Conservation Commission

To: Franklin Conservation Commission
From: Breeka Li Goodlander, CWS, PWS, CERPIT
Re: Conservation Agent Report
Date: January 25, 2024

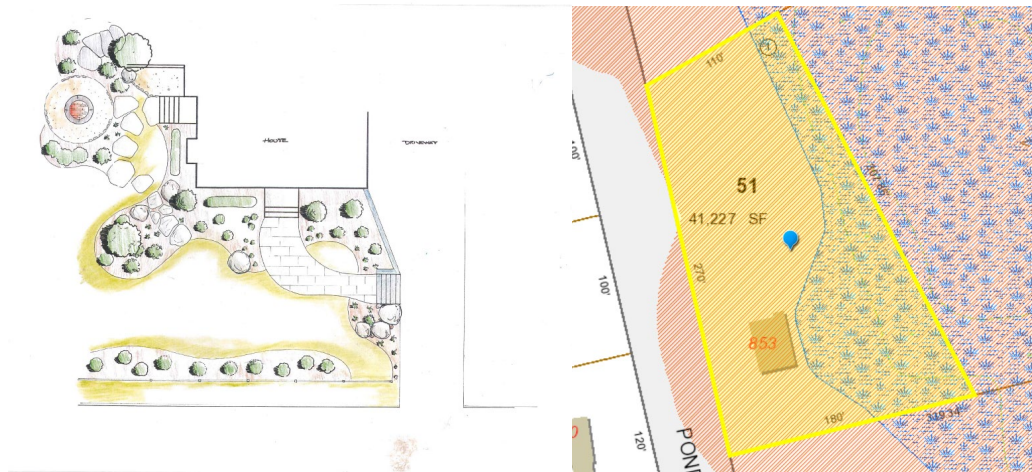
Recommend approval, however the Commission should discuss the request to remove stumps as this is not standard practice of the Commission, and inquire upon the pipe design. Applicant should provide additional sf impacts for the pipe and trench install. It's recommended that the Commission confirm that the installation of a new pipe will not significantly undermine the existing retaining wall and/or it will be engineered appropriately to ensure hydraulic pressure is alleviated. Should the Applicant need time to respond to these inquiries, it is recommended the MBZA be continued to February 8.
